Modify Site Plan to allow for bus routing.

| Site Address/Street: 5441 Watson Drive SE | Between: Crick Avenue | and: |

| APPROVED | | ARCHITECTURAL | STRUCTURAL | MECHANICAL | ELECTRICAL |
|---------------------------------|-----------------|---------------------------------------|------------|------------|------------|
| | TITLE | ADMINISTRATIVE AMENDMENT TO SITE PLAN | | | |

RE: Administrative Amendment to Site Plan
Immigrations and Customs Enforcement
Zone Atlas Pages Q-16-Z

B1 ADMINISTRATIVE AMENDMENT TO SITE PLAN
1" = 30'-0"

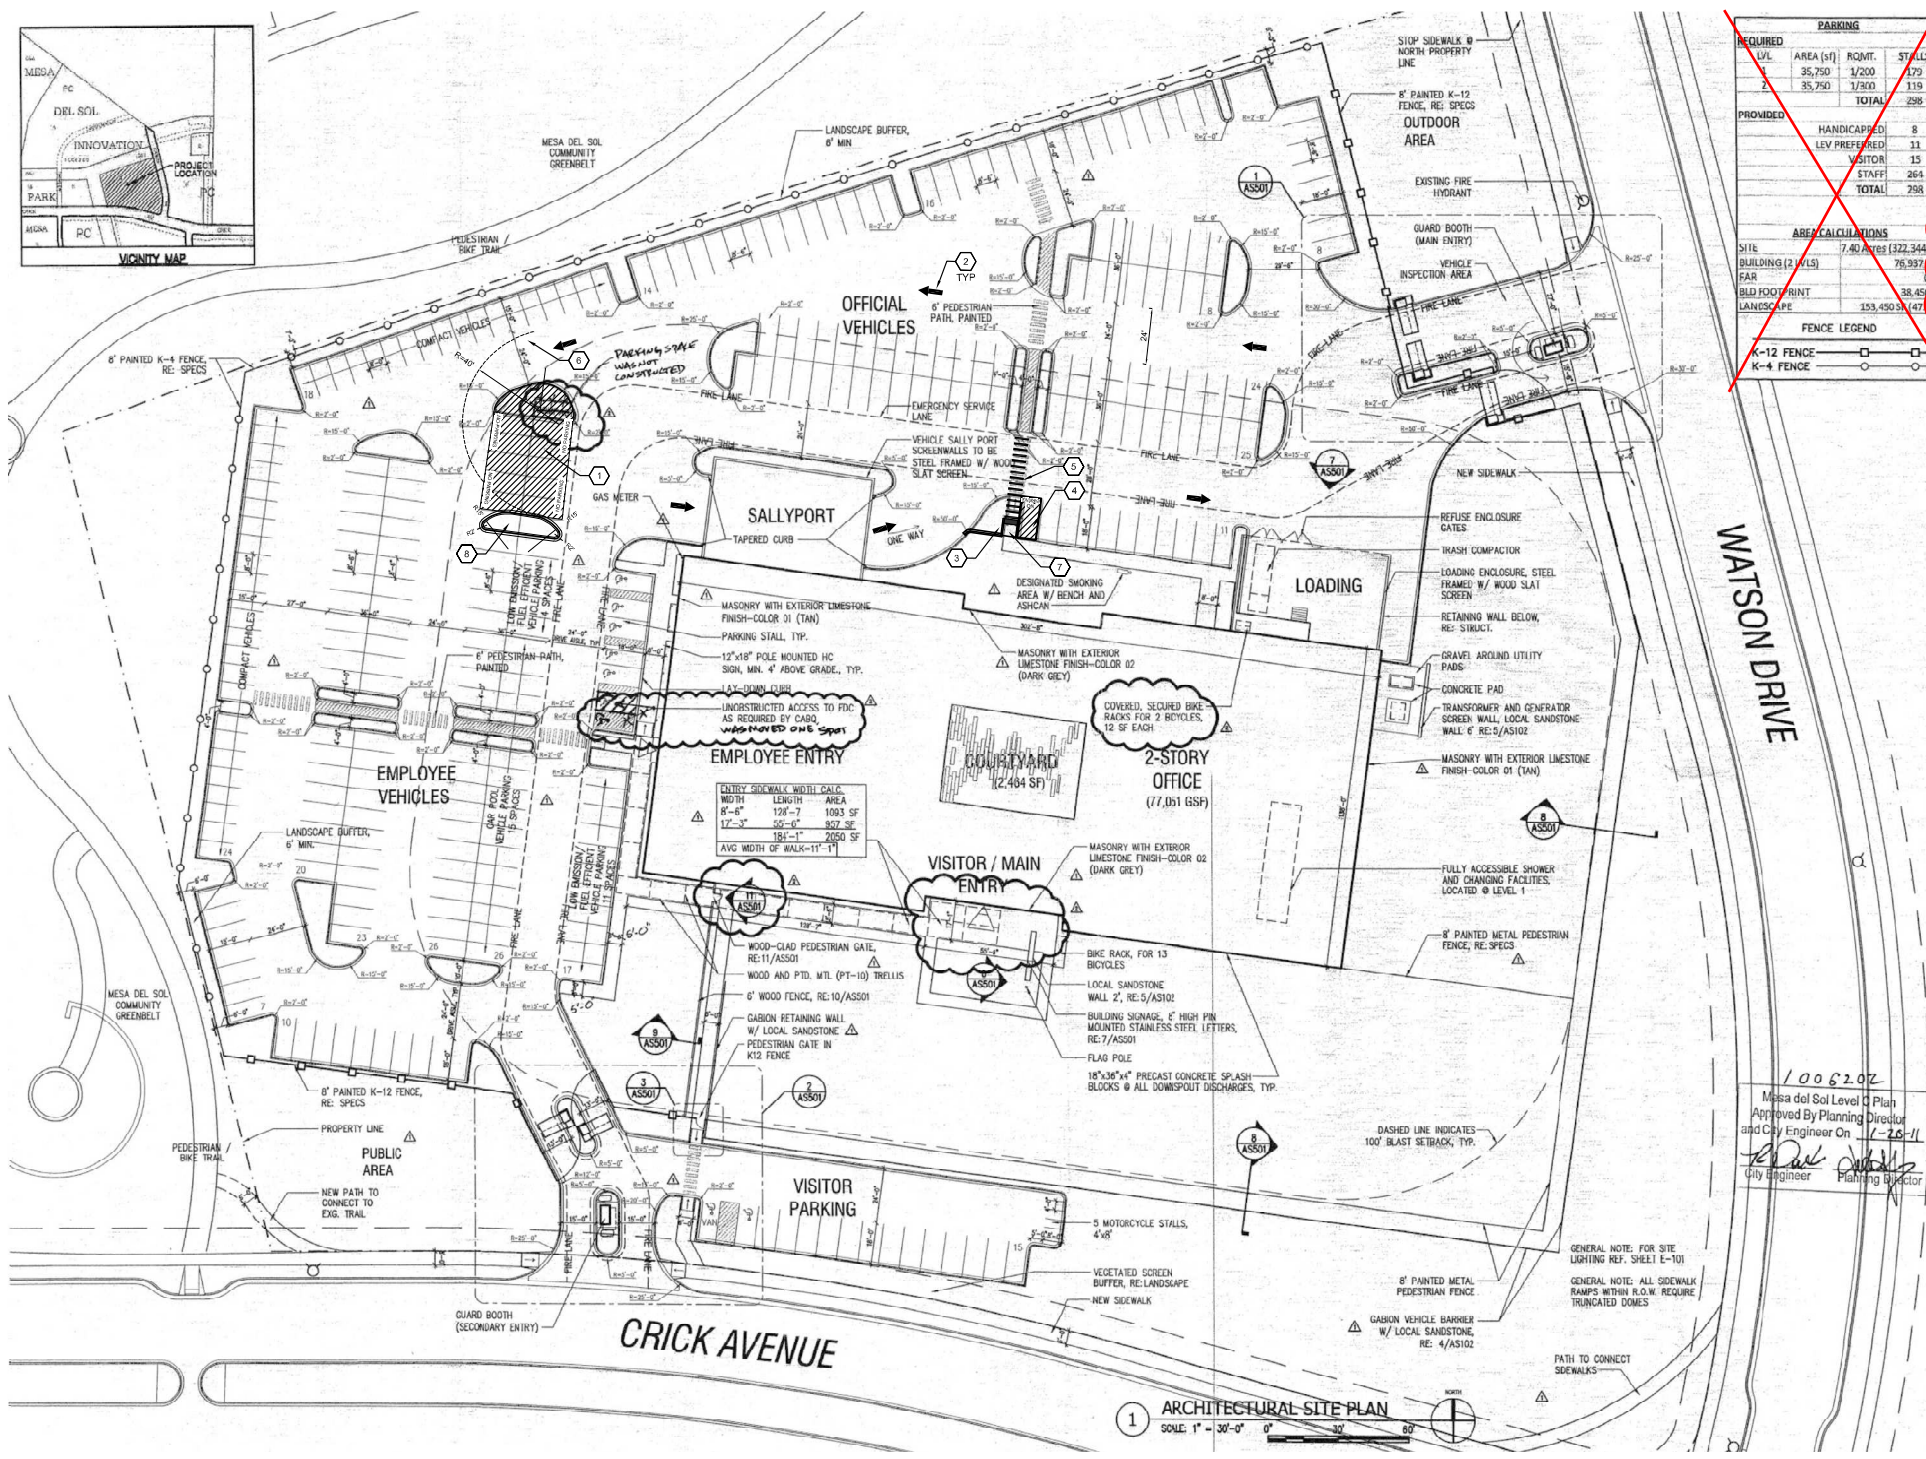
*Refer to Updated Parking Tabulations Below -JMA 10/1/2020

| TITLE | ADMINISTRATIVE AMENDMENT TO SITE PLAN | | | |

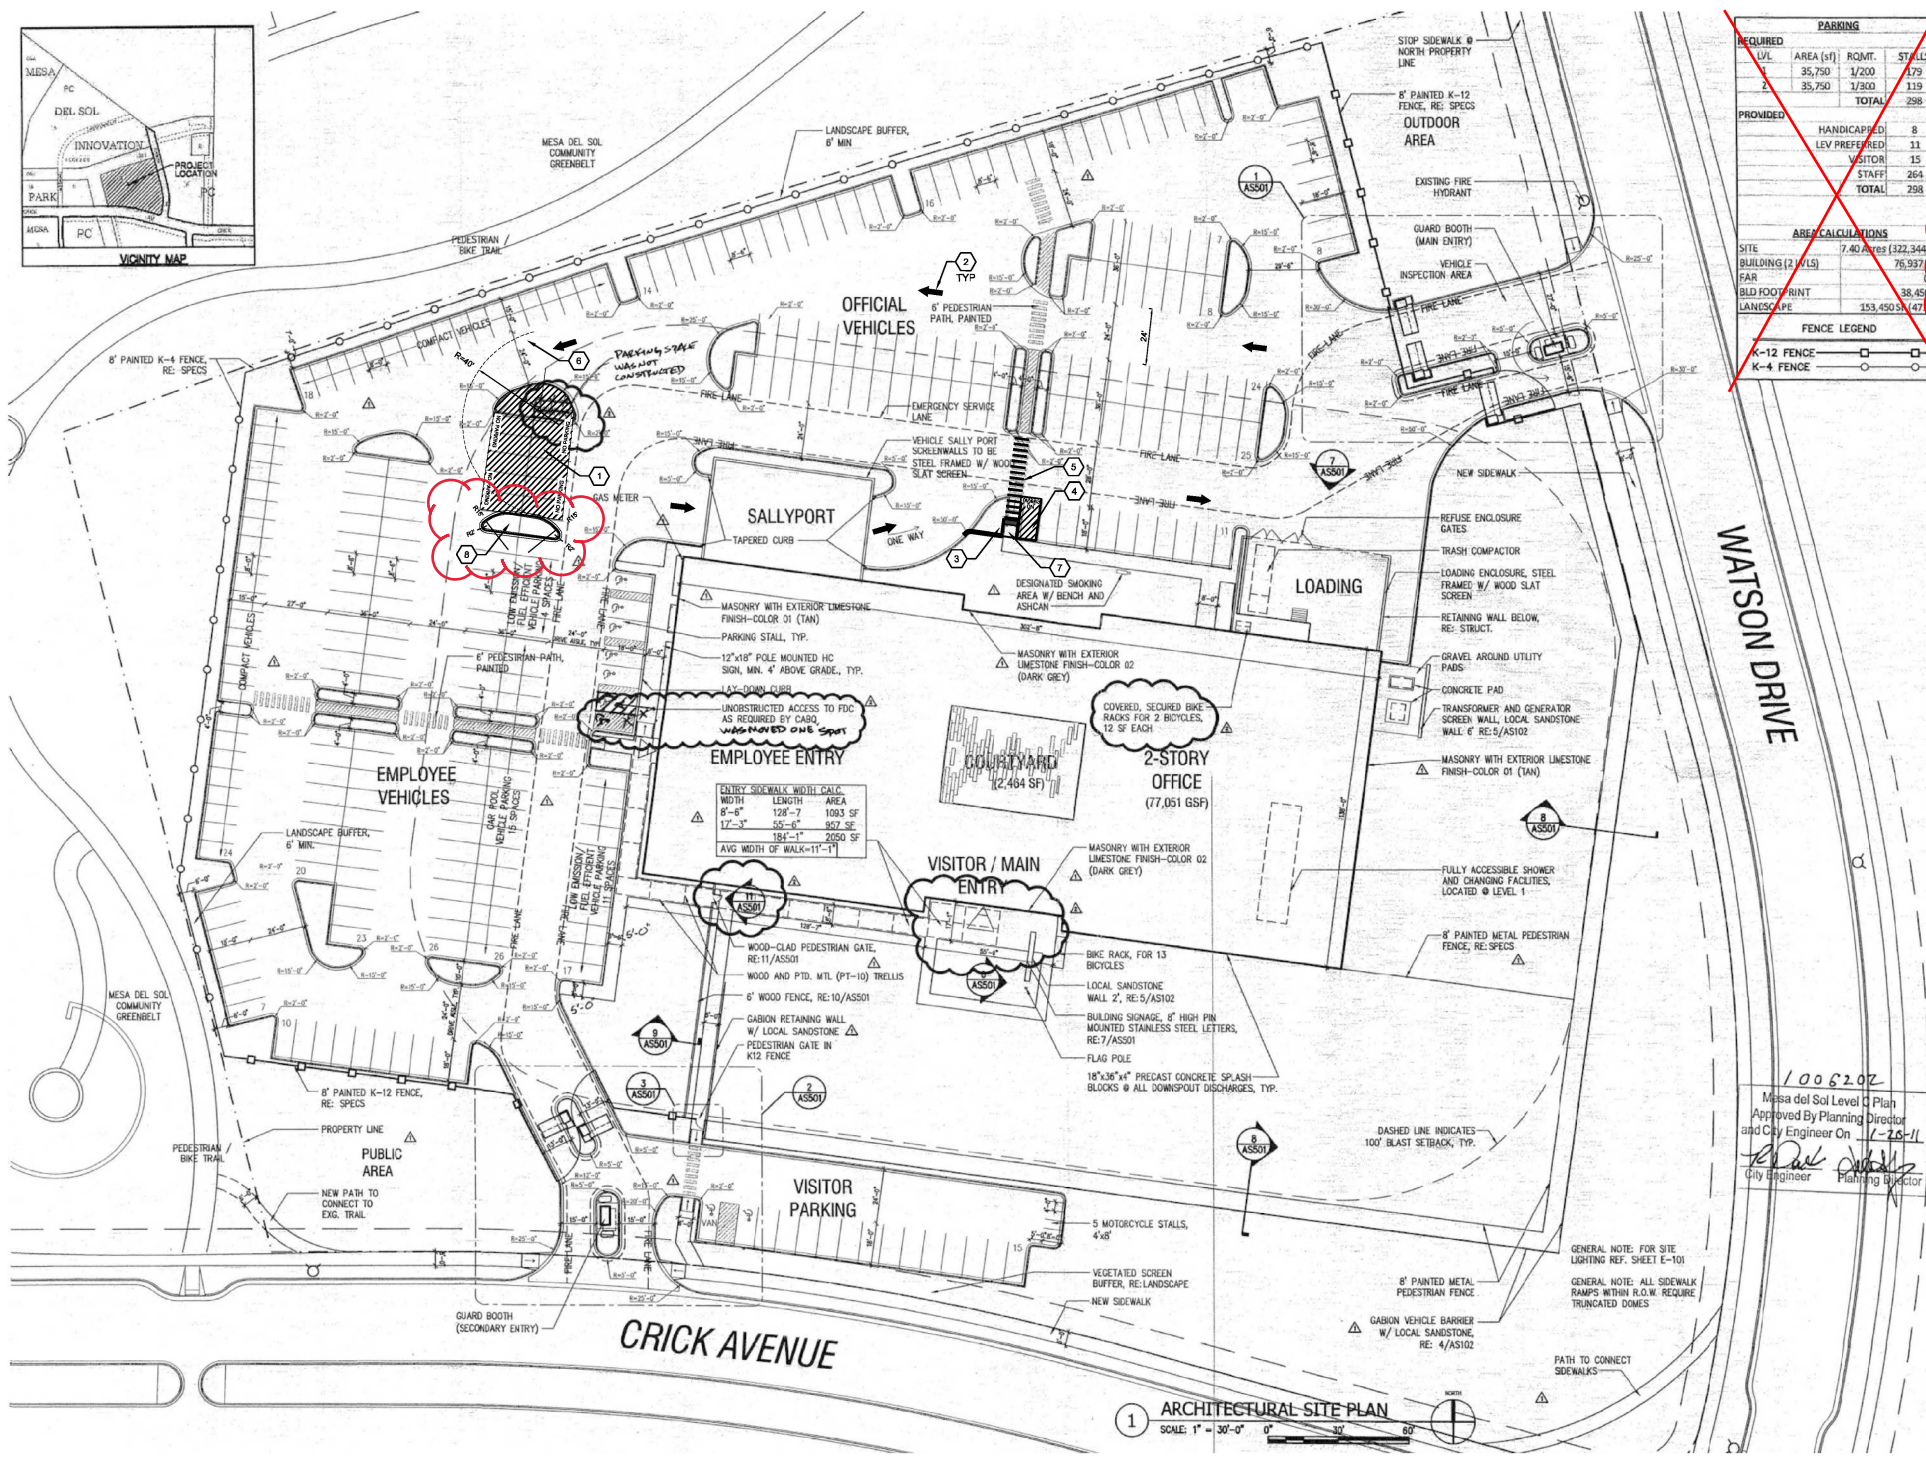
*Refer to Updated Parking Tabulations Below -JMA 10/1/2020

This Administrative Amendment action does not meet the applicability criteria of IDO 5-6(B), therefore no landscaping is required on the proposed end island. JMA 11/20/2020
